## Review of weight limits in Highgate

**Draft note produced by Richard Webber – 11/8/2016**

*Cordon proposed by Haringey*

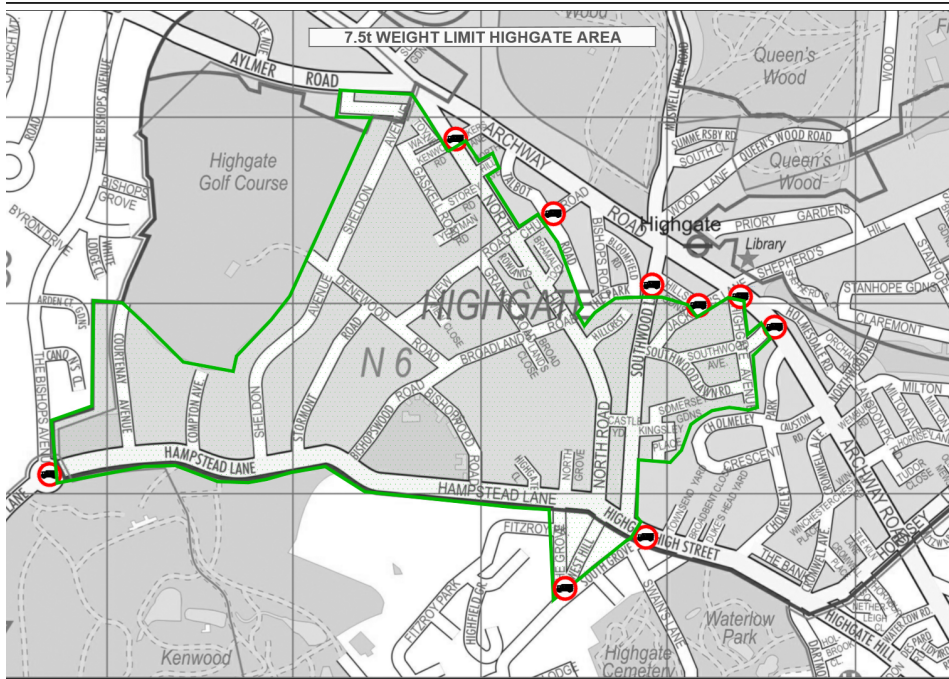
Our understanding is that though these restrictions affect individual streets, the streets affected are defined by the outer cordon, the line of which is shown on the map following supplied by Girma Bethlehem on 29 July.

There are two principal deficiencies in the current arrangements. One is missing and inconsistent signs, the other the inappropriateness of their location.

Again whilst the cordon specified by Haringey Council suggests that the existing traffic order applies to the whole of Southwood Lane as far as Highgate Village, at present the northbound weight restriction sign is located at the junction of Southwood Lane and Jacksons Lane, not at the entrance to Southwood Lane. Assuming the sign outside Channing Junior School is an advance warning sign rather than a control sign, northbound signage allows vehicles over 7.5 tones to travel from Highgate Village to the Archway Road via Southwood Avenue, but again not in the opposite direction.

The other principal deficiency is that were restriction signs to restored to their correct locations, which is what it appears Haringey are proposing, the advance warnings sign outside Channing School is inappropriately sited to alert drivers in advance of arrival at the point of restriction. Vehicles exceeding the weight limit can not be expected to do a U-turn at that point. It would have been much better to warn them at the foot of Highgate Hill rather than at the top.

Our contention is that if the intention of the proposals is to ensure that vehicles over 7.5 tons use the Archway Road rather than Highgate Village there is a need to introduce additional advance warning signs

- In Camden at the junction of Fortess Road and Highgate Road
- In Islington at the foot of Highgate Hill
- In Haringey at the approach to the Archway Bridge on Hornsey Lane

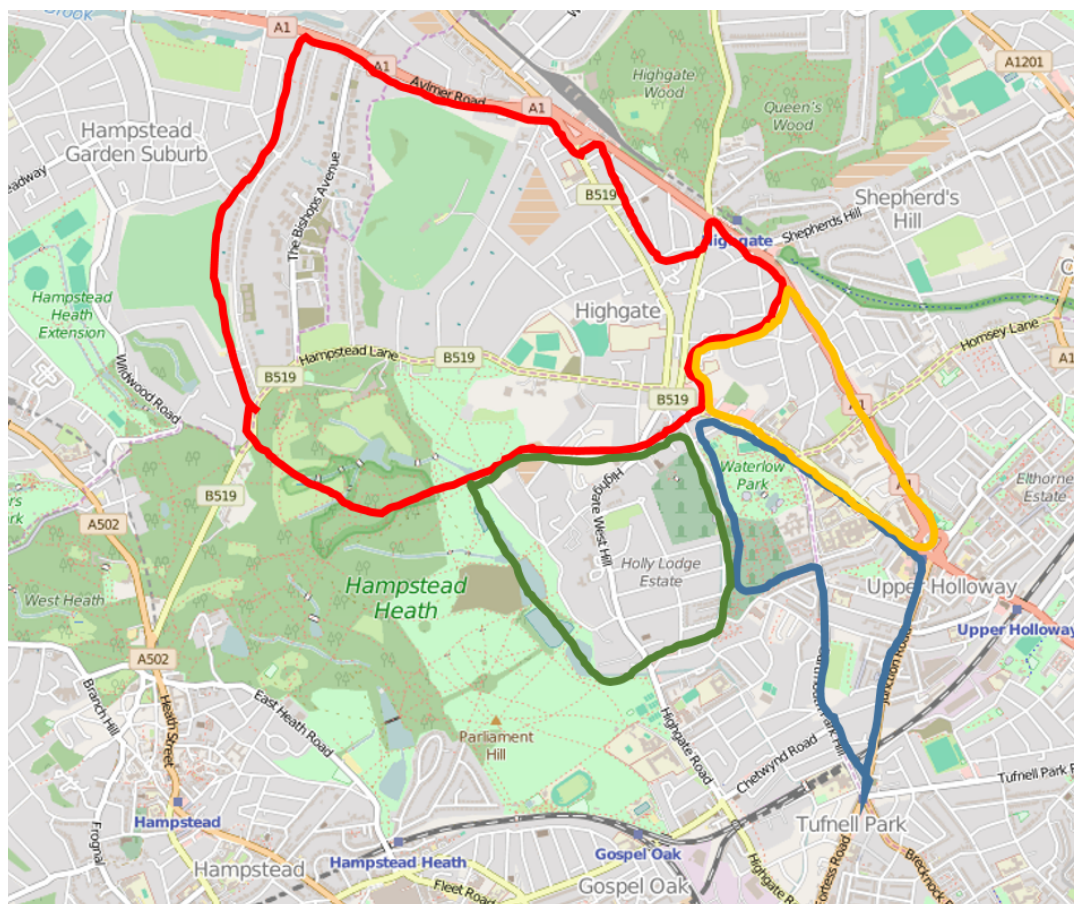
A map showing both the current Highgate cordon and the North Islington one suggests that it would be logical to join the two together to make a single expanded one with a more rational boundary as shown in the map below.

The red cordon is that which Haringey believes the current restricted zone together with neighbouring parts of Barnet which share the same restriction.

The blue cordon is that part of Islington with an existing weight control together with Bisham Gardens.

South Grove is the only route between the two cordons. It is currently restricted in one direction but not in the other, and so status unclear.

The orange cordon contains parts of Haringey and Islington that we believe should be added to the existing restricted areas, together with Talbot Road and Church Road, so as to create a single cordon.

Likewise the green cordon contains parts of Camden, much of it Holly Lodge and Swains Lane which ought not to be left uncontrolled and which, if controlled, would then prevent overweight vehicles having to turn round outside the Flask.
